New Reactors Programme
GDA Close-out for the AP1000 Reactor
GDA Issue GI-AP1000-RC-02 Revision 0 – Primary Sampling Systems

Assessment Report: ONR-NR-AR-16-045
Revision 0
March 2017

Figure 1: AP1000 Primary Sampling System (PSS)

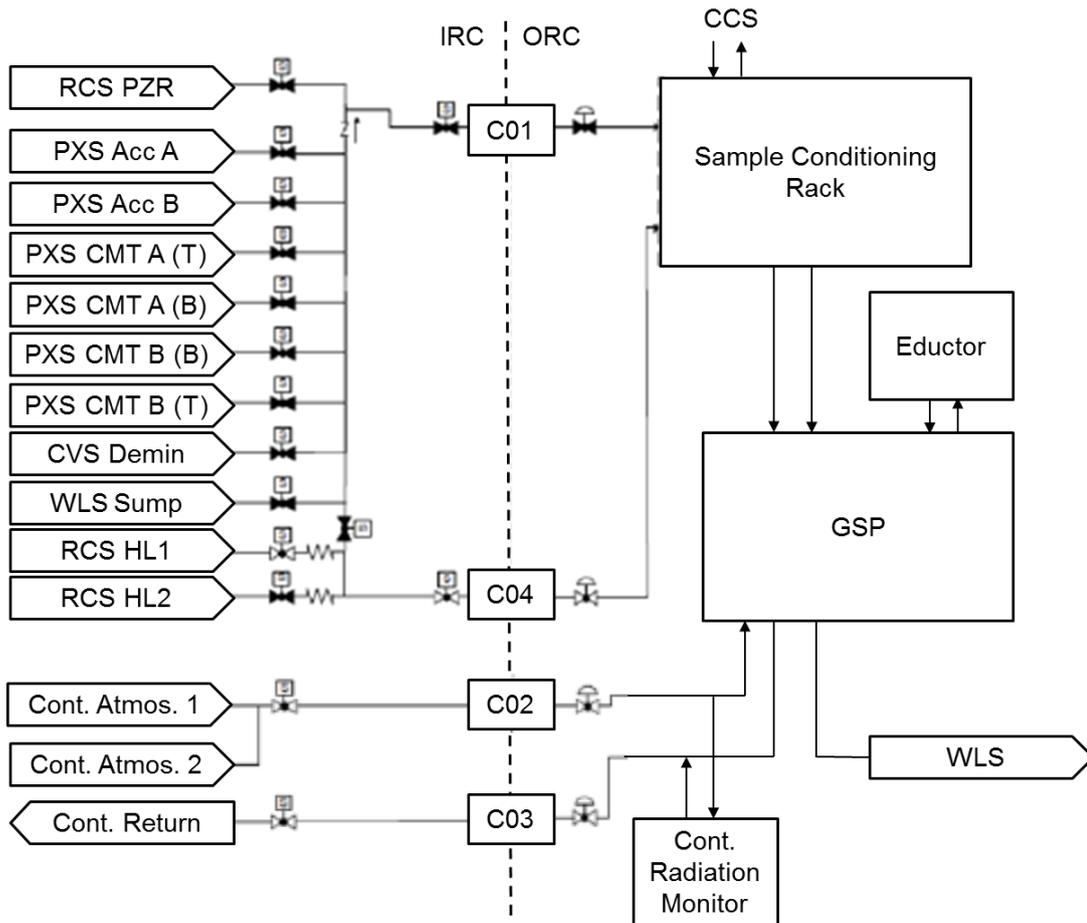
43. This shows the Primary Sampling System (PSS), which is the main system responsible for sampling the primary circuit and related auxiliary systems in the **AP1000** design. The PSS includes the capability for sampling both liquid and gaseous samples (of the containment atmosphere) during normal operations. Westinghouse states that the PSS must be available for monitoring of the primary coolant during all of the plant operating conditions. Alongside the PSS are a large number of (over 30) 'local' sampling points where grab samples can be taken. These are discussed later in my assessment, and include the boric acid make-up tanks, Residual Heat Removal System (RNS) and In-containment Refuelling Water Storage Tank (IRWST) (through the RNS). Although not part of the PSS, they are within the scope of the primary sampling systems considered by GI-AP1000-RC-02. It should be noted that Figure 1 also includes a design change (Ref. 17) made late within Step 4 to address some of the issues found during the ONR assessment. In short, this change added the second, continuous sample line. Prior to this all the samples passed through a single, intermittently used line. This change was mainly to address concerns over sample representativeness and a lack of redundancy in the system.

Figure 2: Boron meter modifications schematic

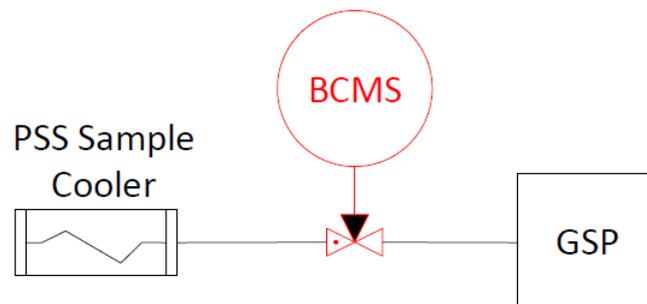
98. Five options were devised which would give the **AP1000** design the capability to monitor boron on-line. Once subjected to the ALARP assessment, two of these, relating to adding an entirely new sample line and introducing a small circulatory loop fed from the primary circuit within containment, were discounted. The latter was deemed to be infeasible while the former scored poorly due to the safety detriments it introduces (mainly increasing the radwaste and an increase in plant risk caused by an extra containment penetration). The scores from the remaining options ranged from slightly detrimental to beneficial (-0.2 to +0.05). Therefore, there seemed little to choose between these options. Westinghouse stated that their preference is to include a boron meter (BCMS – Boron Concentration Measurement System) upstream of the GSP which would make use of the existing continuous sample line. This is shown in Figure 2.

99. On the basis of the evidence presented in Ref. 19, I am satisfied with the consideration given to the inclusion of a boron meter in the **AP1000** design and welcome the proposed change to introduce one.

100. Given the close scoring of a number of different options for how this might be achieved, I queried this in RQ-AP1000-1728 (Ref. 26). The response indicated that the main difference between the options relates to the space available within the GSP and sampling room to be able to accommodate this additional equipment, which is currently restricted. Westinghouse indicated that the detailed design phase will influence the final solution, but at the moment the option to include a meter external to the GSP is seen as optimum. Also, the option of including a non-intrusive external meter based on neutron absorption technology (ie on the outside of pipework) scored low, mainly because Westinghouse considered that this needs to be located on part of the CVS and therefore inside containment. This introduces additional detriments, such as maintenance access. Given the clear safety benefit of this type of technology, mainly by not requiring a break in the containment barrier, I would expect further consideration to be given to whether it is reasonably practicable to include such a meter elsewhere within the plant.

101. Overall therefore, I am content that a boron meter will be included within the UK **AP1000** plant design. This represents a safety improvement. Further justification will need to be provided by the licensee regarding how and where this is implemented within the design and safety case. Given the expected boron control operations in the **AP1000** reactor, I am satisfied that the current proposed design, as defined within Ref. 19, could be demonstrated to be sufficient but this will need to be done at the detailed design phase and with suitable operator input. This should also include matters such as how the boron meter outputs are used by the operators, for example within the control room, the meter technology, its uses by the operators and reliability claims on the meter. **I consider this to be an Assessment Finding:**

CP-AF-AP1000-RC-02 – The licensee shall provide justification for how the boron meter is to be implemented within the detailed plant design and safety case, given the design change to incorporate the capability.

Figure 3: Corrosion product sampling modifications schematic

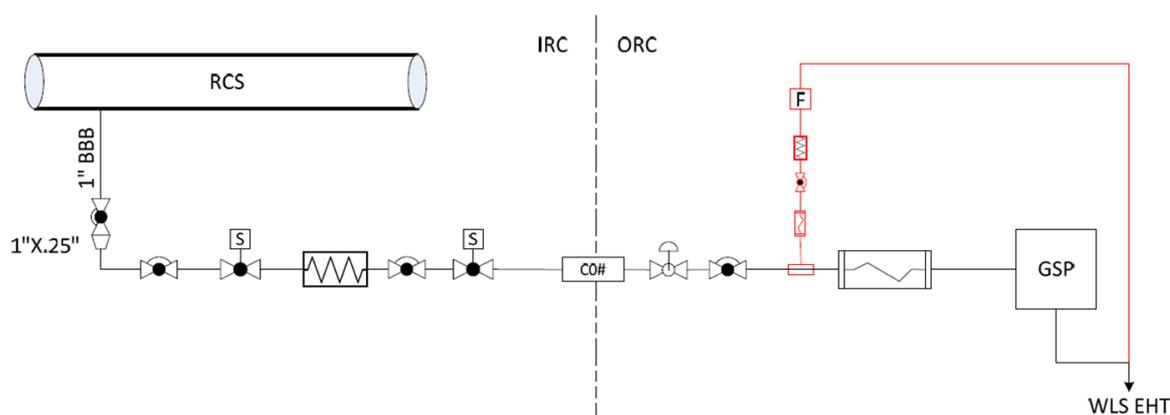
105. The final option, of capillary line sampling, has therefore become the selected option. Similar approaches have been used in a number of operating plants worldwide, including Sizewell B in the UK (Ref. 36, for example). As the proposed modification for UK **AP1000** plants will draw flow from the existing continuous hot leg sample, this should meet the RGP defined in Ref. 18. It also has the advantage of creating no additional sampling effluent, as this flow already exists. This is shown in Figure 3.

106. I am satisfied with the consideration given to the capabilities of the **AP1000** design to sample CPs. The addition of a capillary filter sampling device is consistent with many plants worldwide and addresses the deficiencies in the original design. However, this modification will only prove successful if the continuous hot leg sampling line is representative of the main primary coolant flow. I consider this further in Section 4.2.2.4 of my assessment.

Figure 4: Sample header modifications schematic

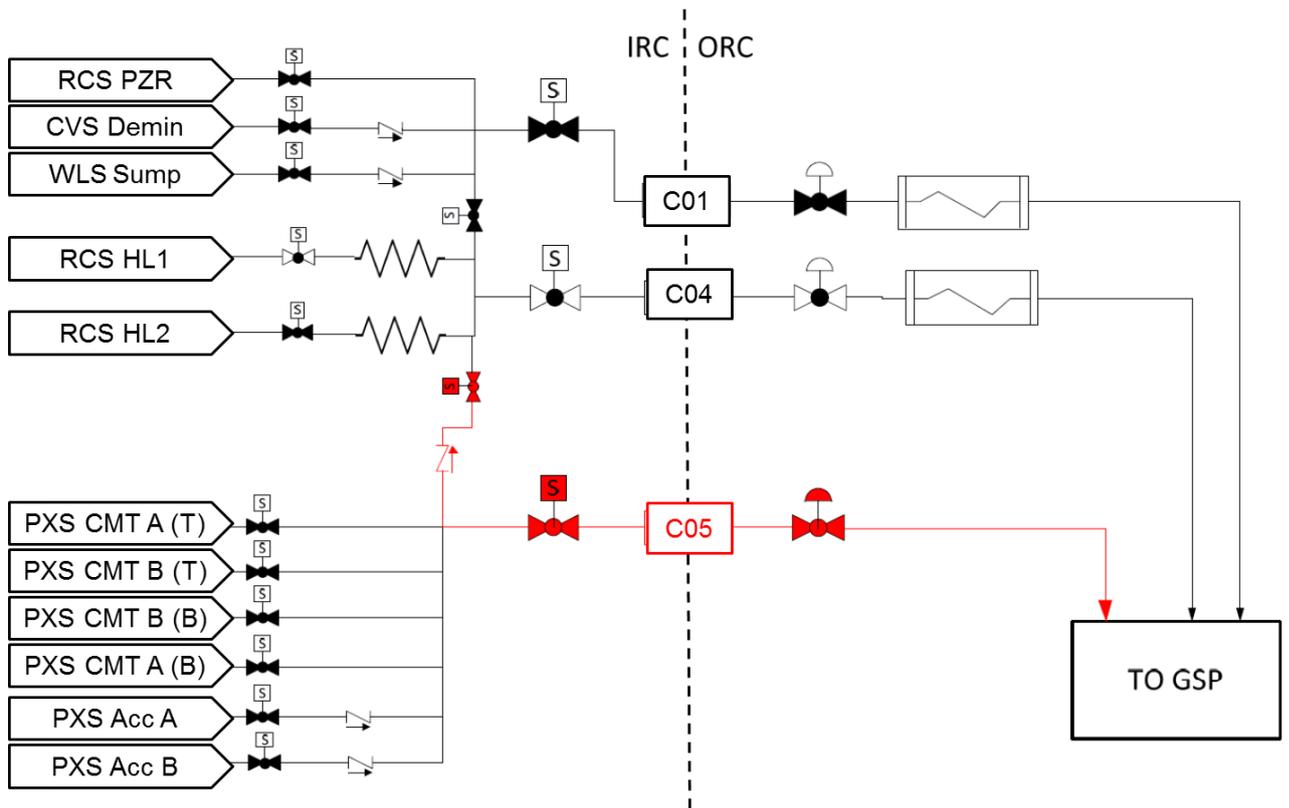
132. The other, less extreme, option further splits the manifold. The rationale for this split is based on grouping similar samples, for example the PXS samples are all of similar composition, temperature and pressure and the main requirement is for soluble boron concentration. The benefits and detriments for this option are broadly the same as the previous option; however, the scale of detriments is much smaller given that only one additional (intermittent) sample line is necessary. This alters the ALARP balance and, overall, Westinghouse concluded that it is reasonably practicable to implement this change. This is shown in Figure 4.

133. In effect, this modification creates three sampling manifolds inside containment, each with their own sample line that passes through containment. These are not normally connected, but can be so if necessary due to failures or other reasons. One of these lines (via C04) is continuously open, drawing flow from hot leg 1 (or 2). The other two (PXS samples via C05 and others via C01) are used intermittently in accordance with the sample schedule. I am satisfied that this further split of samples is reasonable. If operated as intended, this arrangement groups similar samples through the same line, minimising the chance of obtaining unrepresentative samples through cross-contamination. Although the WLS sump sample is grouped with the pressuriser liquid and CVS demineraliser outlet sample, it is not intended to be used during normal operations and is mainly included for post-accident situations.

134. I am content that this change improves the PSS and reduces the risks associated with obtaining a non-representative sample. This also allows the operator additional flexibility in sampling, for operational reasons or due to some fault or failure in the PSS. Given the other facets of the **AP1000** design, I agree that this represents a pragmatic solution, and do not think that any further modifications (for example, to four sample lines) would yield any further benefits to nuclear safety. I judge that this resolves the concerns with this aspect of the design.

Figure 5: Effluent recycle modifications schematic

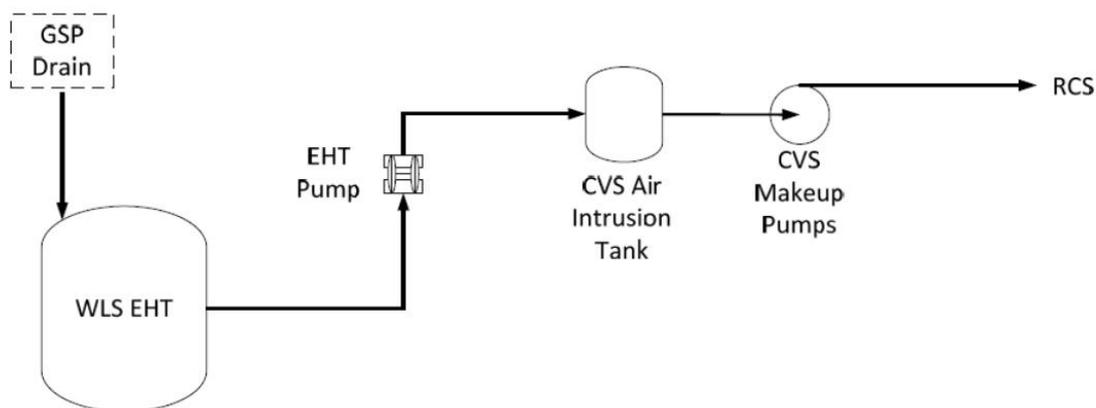
140. The conclusion of the ALARP assessment discounted both of these options. The second option, of re-tasking an existing EHT, showed a smaller overall detriment, mainly associated with increased dose to operators. This option is shown below.

141. This scoring was heavily reliant on a number of assumptions. The main ones were that: the effluent must be held up for a long period (numerous days) before it can be recycled, the recycling needs to take place via the existing CVS make-up pumps, and all of the PSS waste is recycled. My consideration of these is:

- The **AP1000** plant is intended to operate with infrequent boron dilutions being necessary (at around weekly intervals), with short-term reactivity control achieved using the grey rods. In the current design, the sampling volume is lost from the system, so the primary circuit inventory is losing around 0.7 m³ per day, out of a volume of around 200 m³. Typically, several mg kg⁻¹ of boron are burnt up in the coolant each day. Using these values, it is possible to estimate the change in primary coolant boron that would result from recycling the sampling effluent with different hold-up times. The increase is shown to be exponential, such that after 5, 10 and 30 days the primary circuit boron would increase by around 0.1, 0.6 and 6 mg kg⁻¹ respectively. The same is true if dissolved oxygen is considered, but the difference here is that the dissolved hydrogen added to the coolant would rapidly remove this. The net effect would be a reduction in the dissolved hydrogen concentration. Assuming 30 days hold-up and effluent saturated with dissolved oxygen, this would reduce the hydrogen concentration from 25 to just under 24 cc kg⁻¹. I am therefore not convinced that these effects are as significant as was suggested in Ref. 19, particularly if the recycling can take place on a more frequent basis.

- Using the CVS make-up pumps will add the effluent at a high flow rate. However, it is being taken from the primary circuit at only around 30 litres hr⁻¹ and it would seem sensible to try and return it at a similar low rate, ideally on a continuous basis. This would require a similar flow rate to the current zinc injection system in the **AP1000** design (Ref. 43), which suggests this is feasible from an engineering viewpoint. Not using the CVS make-up pumps may also allow the return to feed back into a different location in the CVS, with upstream of the demineralisers and filters potentially offering advantages in clean-up.

CP-AF-AP1000-RC-06 –The licensee shall provide justification for the omission of the capability to recycle the sampling effluent, in order to minimise the production of radioactive waste as low as reasonably practicable.

Figure 6: Final design of the UK **AP1000** PSS in response to GI-AP1000-RC-02

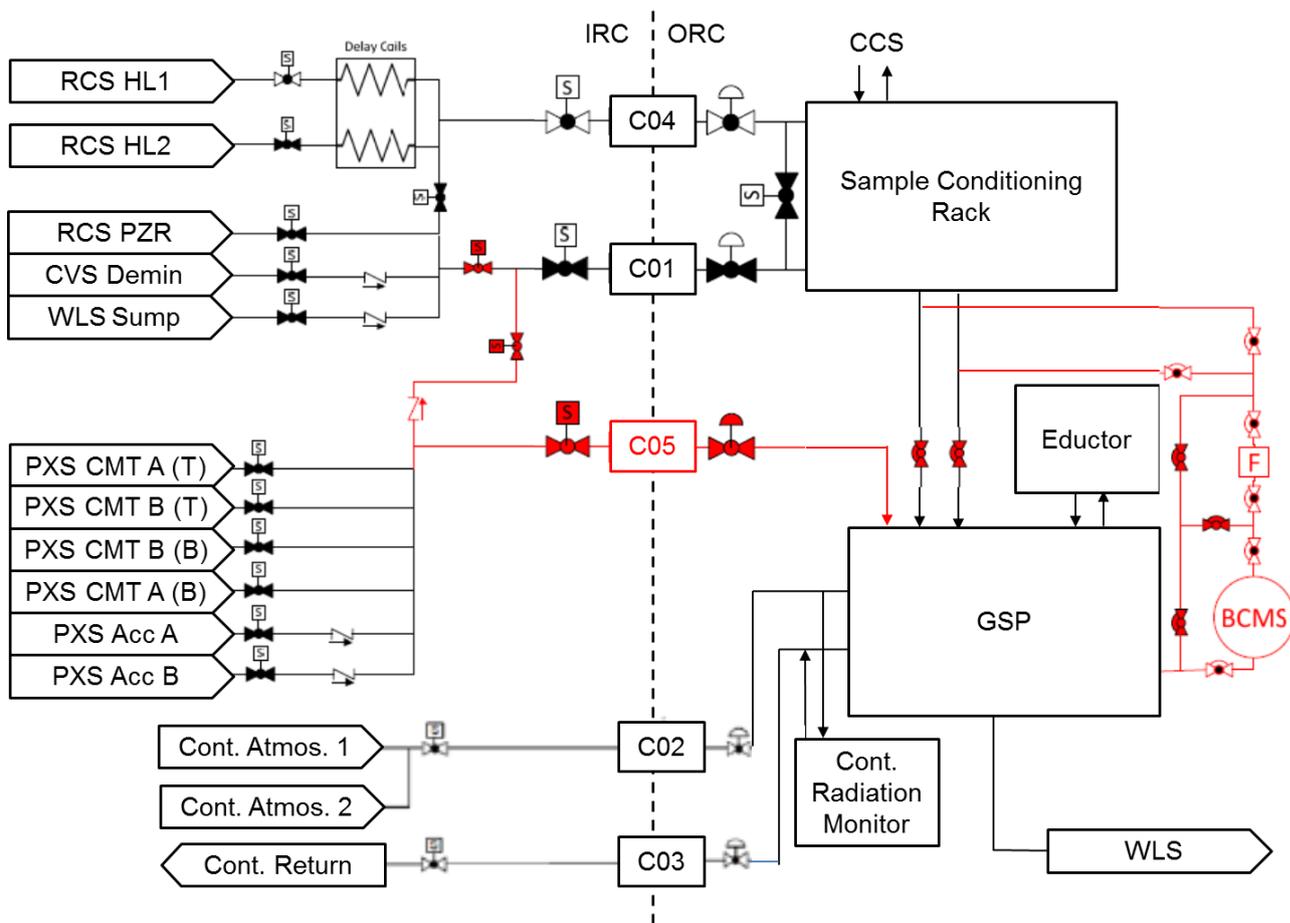
151. In Ref. 19, design modifications were proposed in a number of discrete areas (namely sample header configuration, on-line boron metering and corrosion product sampling). These individual design modifications have been applied to the existing PSS design, resulting in an integrated PSS design. This differs slightly from the individual changes shown earlier, but provides the same functionality. This is shown in Figure 6.

152. As noted previously, Ref. 19 also examined a number of other ‘integrated options’, which consist of various combinations of individual modifications considered against each RGP gap. These were mainly rejected on an individual basis, but are reviewed again to determine if collectively the same conclusion remains. Figure 6 is one of these options, and is the only option selected as reasonably practicable to implement. I consider it a strength that Westinghouse has considered the design holistically, and well as in response to individual RGP gaps. Overall, given my assessment of the individual RGP gaps discussed in the previous section of my report, I support the conclusion that the other integrated options considered do not provide additional safety benefits over the design shown in Figure 6.
